ADDENDUM NO. 1

RE: Controls Upgrade Mayfield Woods MS (HCPSS Bid #096.23.B3)

**FROM: Purchasing Office
Howard County Public Schools
10910 Clarksville Pike
Ellicott City, MD 21042
(410) 313-6723
(410) 313-6789 fax**

1 PART PLAN - MECH. MEZZANINE (E-23, E-24 & F-31)
SCALE: 1/4" = 1'-0"

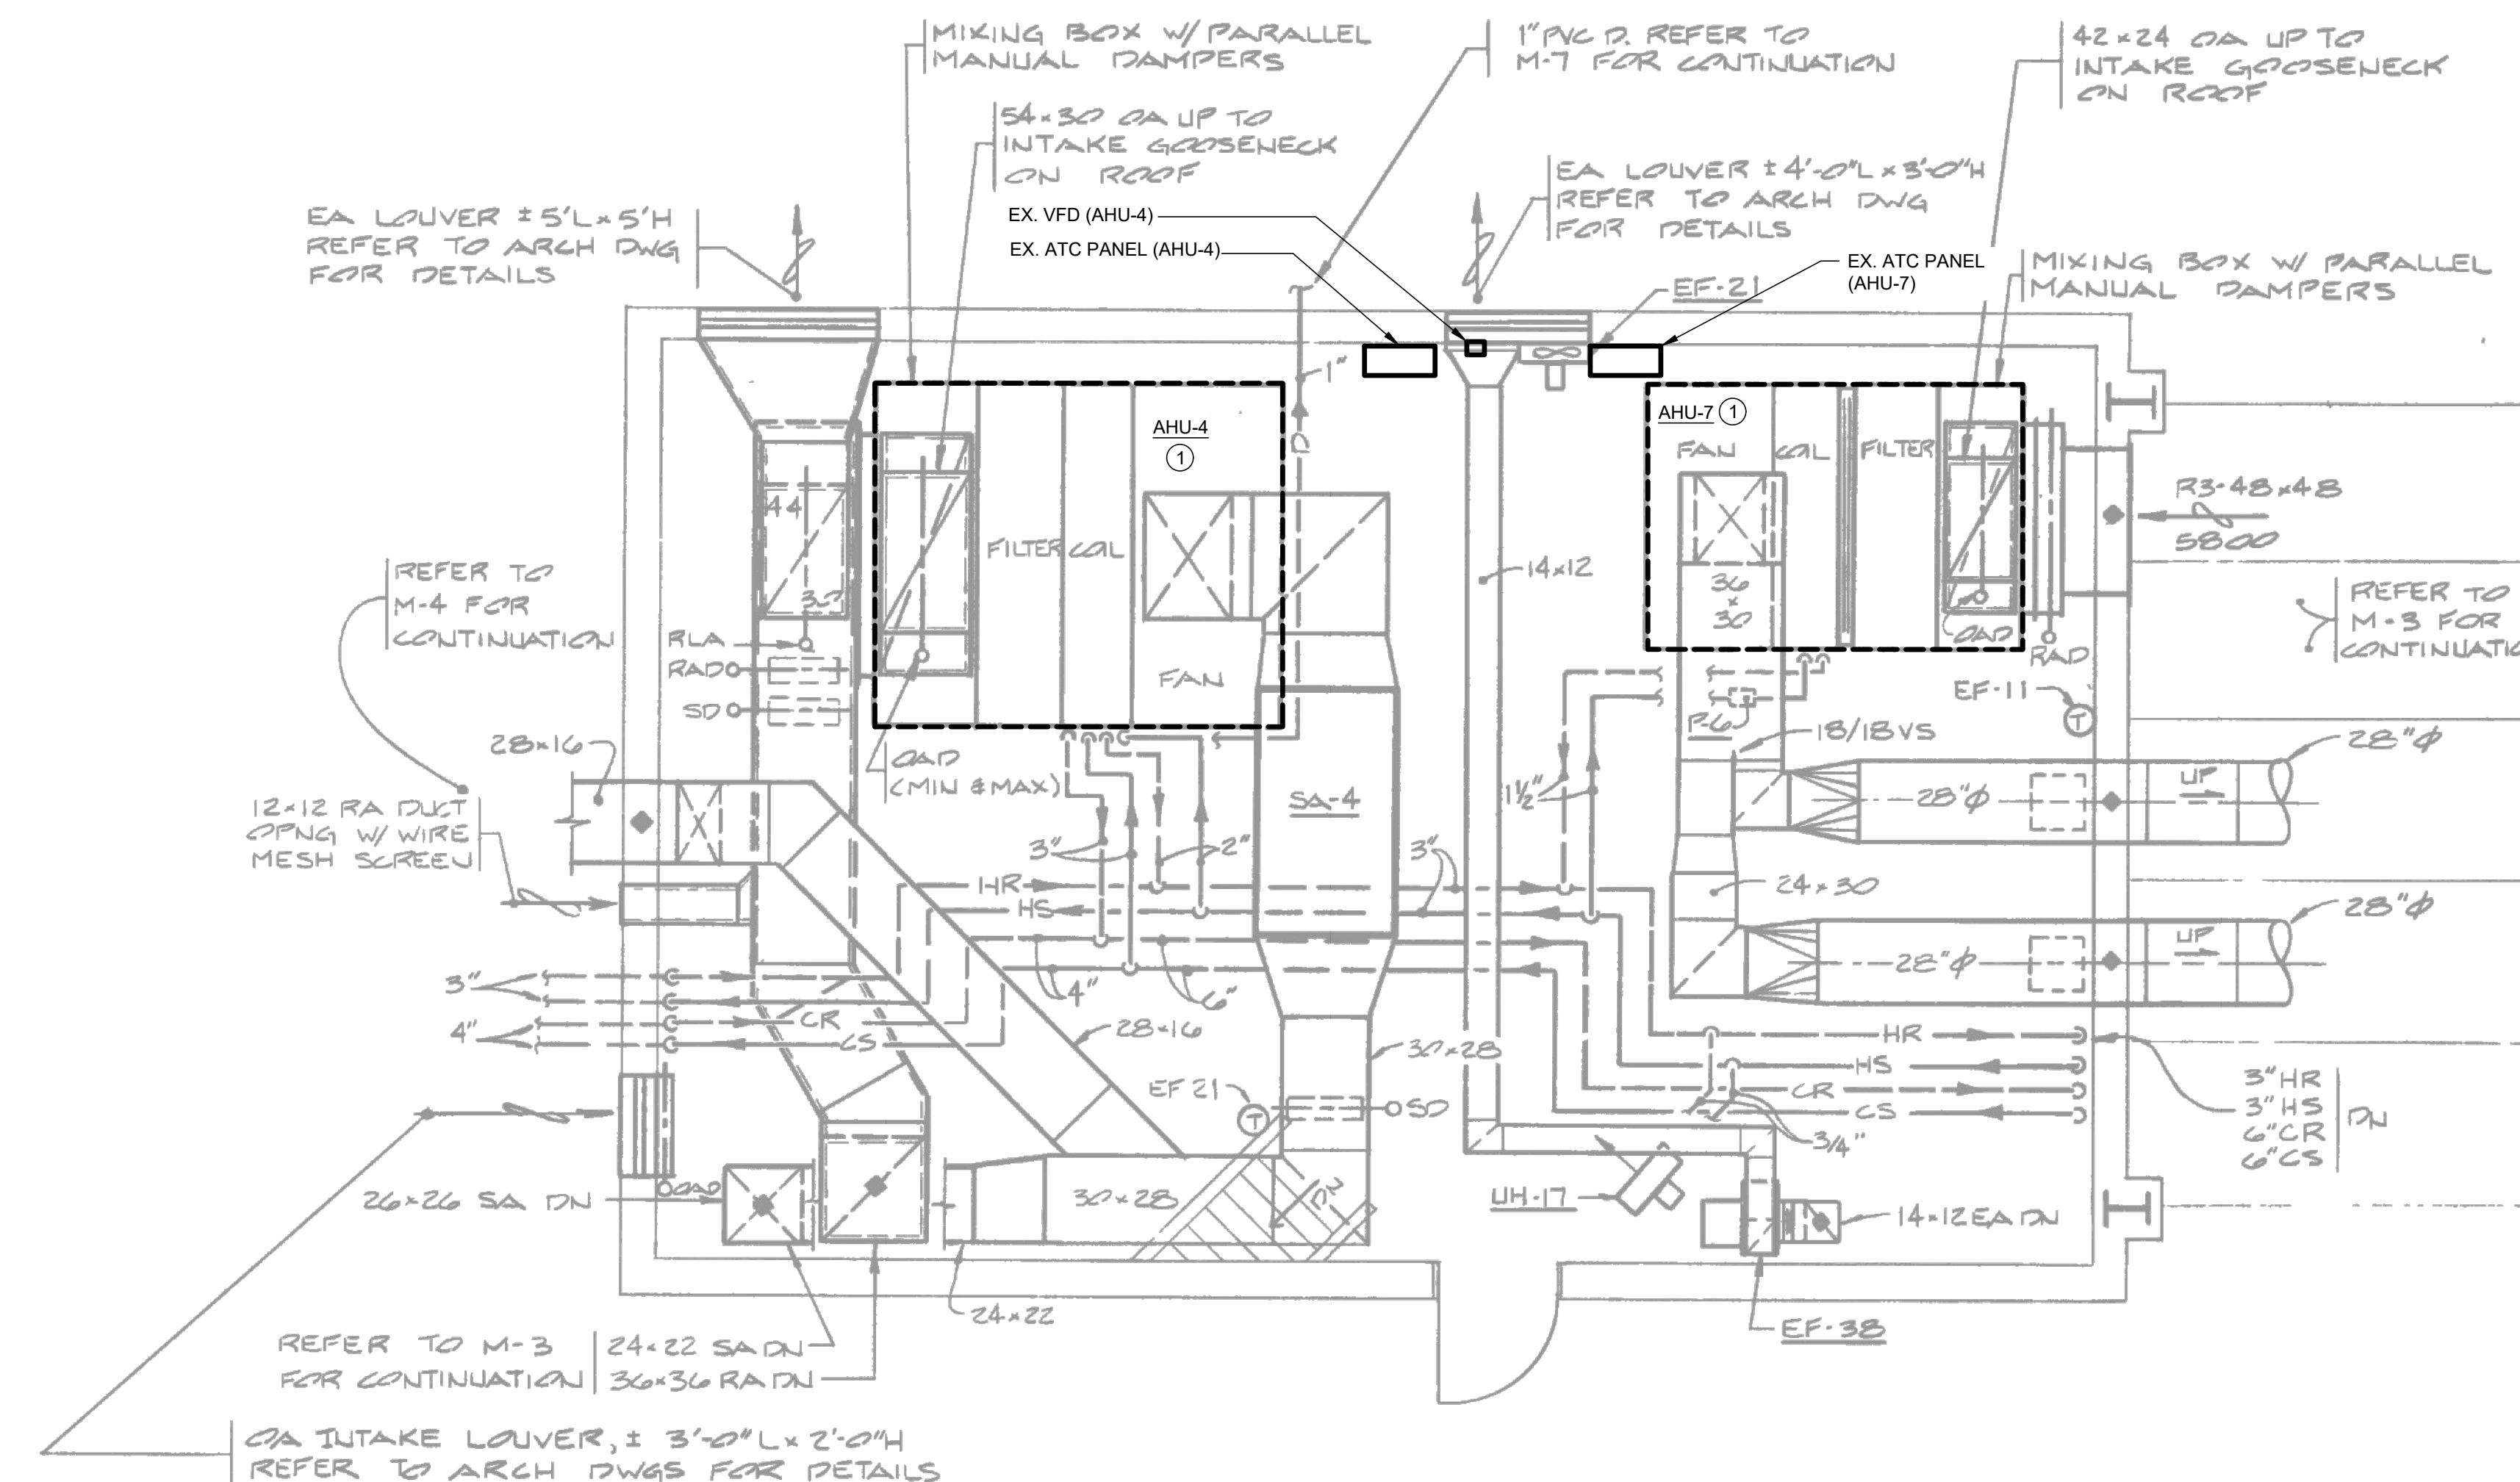
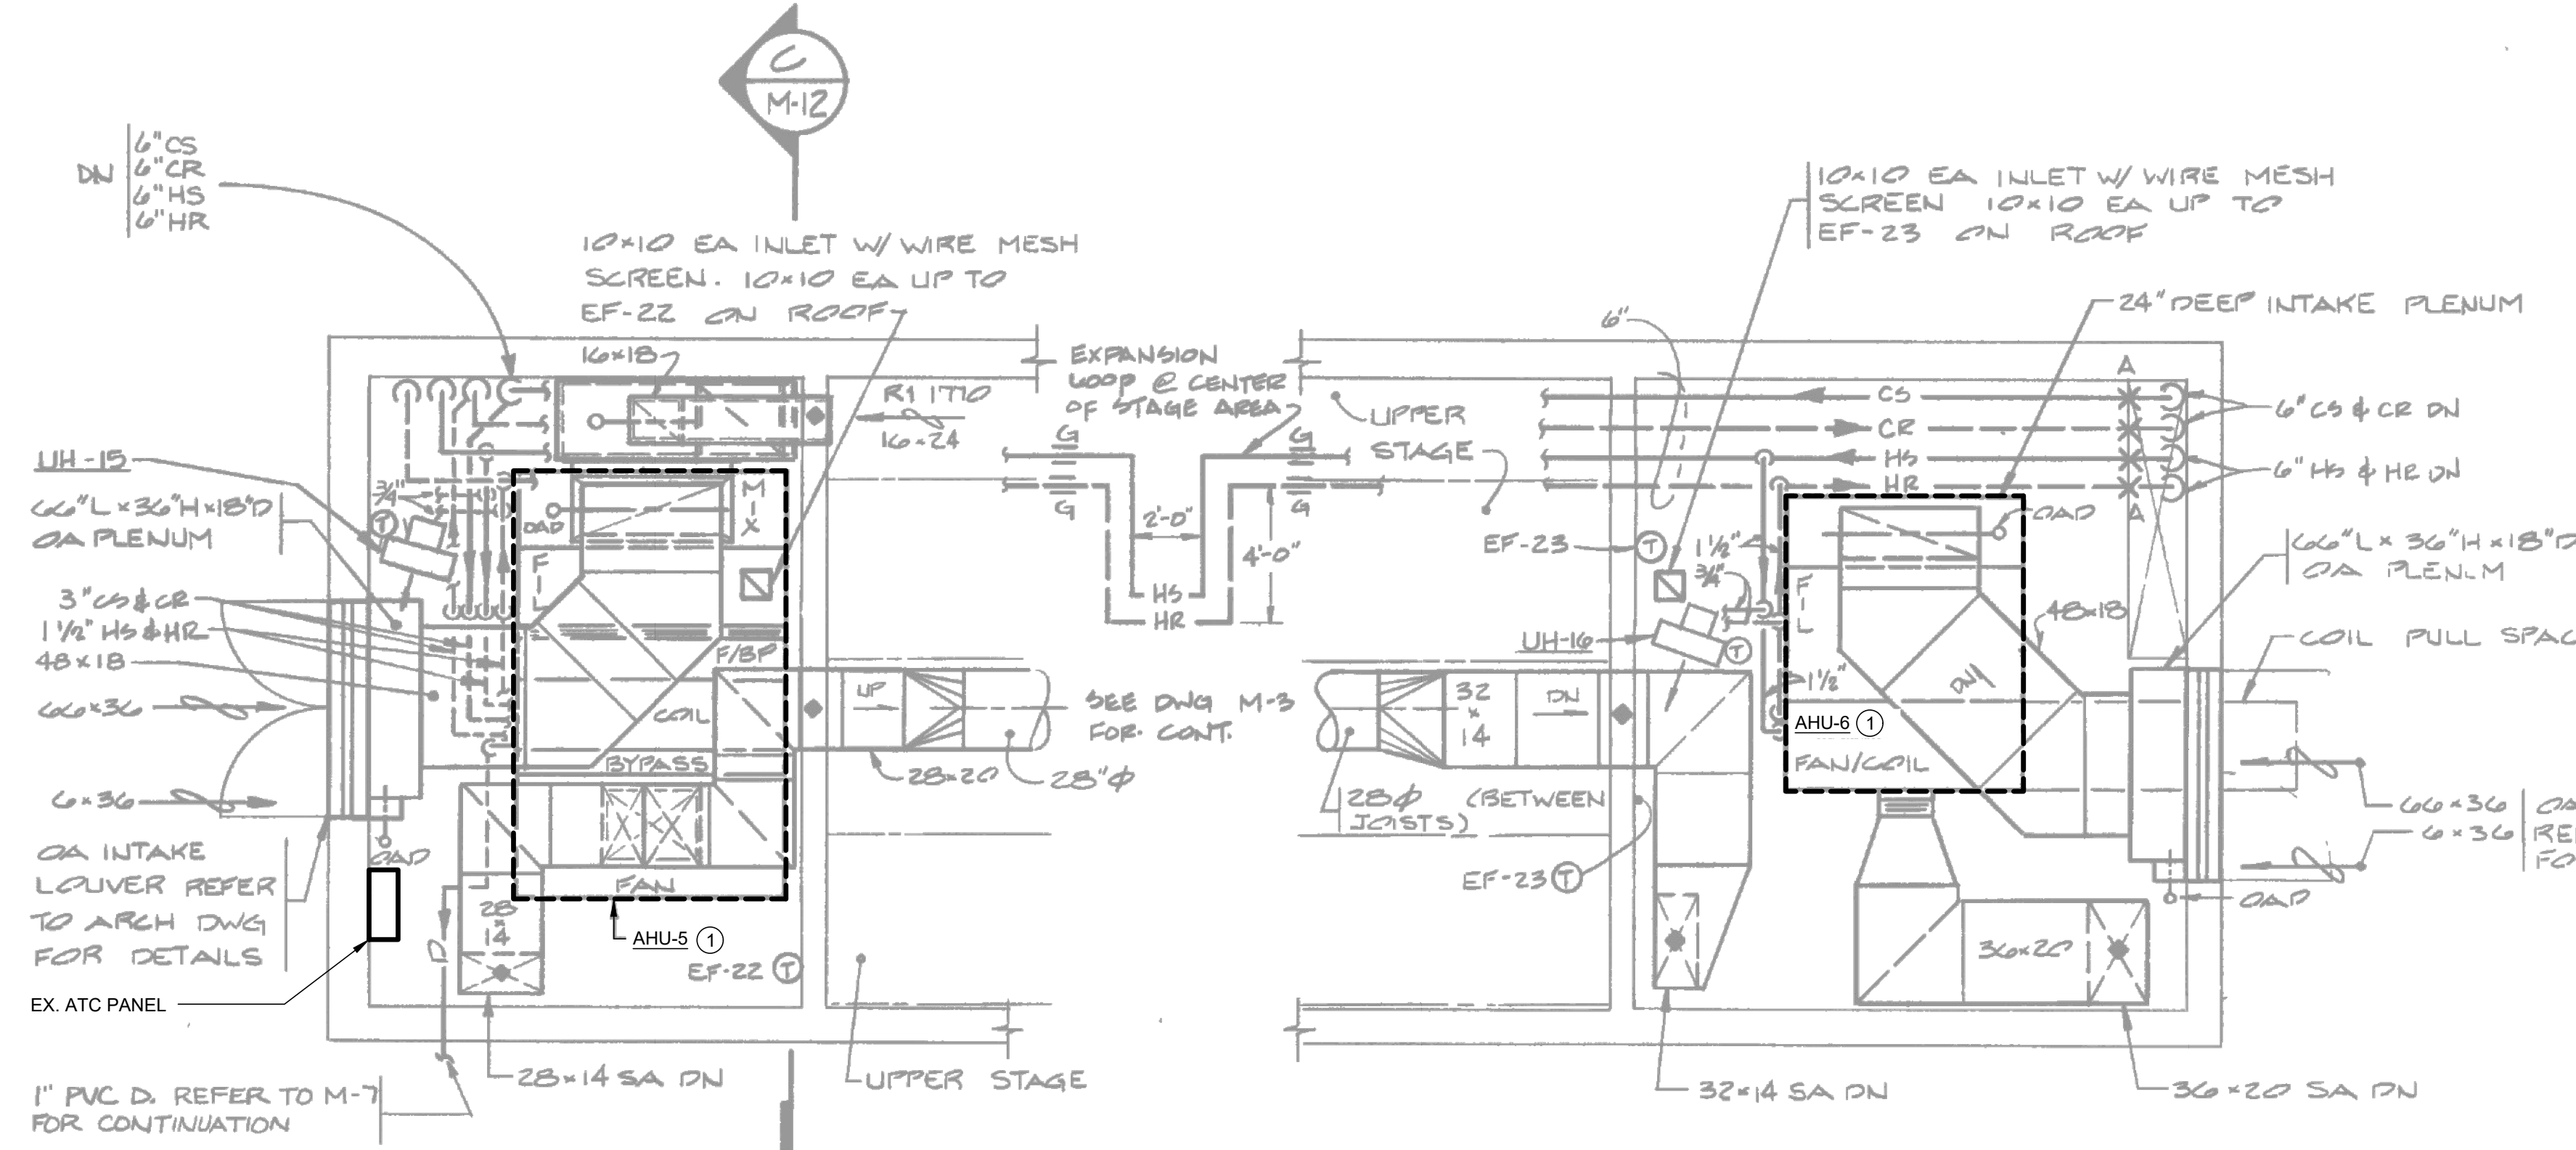
1. **Drawings M2.3:**
 - a. Identified location of ATC panel in Boiler Room.
2. **Drawing M2.7:**
 - a. In Part Plan 1, added Table / Notes.
 - b. In Sheet Note 1, deleted "Honeywell Spyder".

DETAILS A/B/D/E SHOWN ARE TYPICAL FOR MER E-23, E-24, AND F-31, EXCEPT FOR THE EQUIPMENT DESIGNATIONS & DUCT SIZES SCHEDULED AS FOLLOWS:

ITEM NO	EQUIPMENT DESIGNATION	SA DUCT SIZE	EA DUCT SIZE
1	ME ROOM:		
F-31	AHU-1 SA-1 EF-1 EF-26 N/A UH-12	10x36 30x24 30x16 24x22	18x12 N/A
E-24	AHU-2 SA-2 EF-2 EF-27 EF-4 UH-13	10x36 30x28 30x18 24x22	18x14 12x10
E-23	AHU-3 SA-3 EF-3 EF-28 N/A UH-14	8x36 30x28 28x16 28x24	18x12 N/A

REMARKS:
EQUIPMENT 7 = MINIMUM OUTSIDE AIR DAMPER AND VELOCITY PRESSURE STATION.
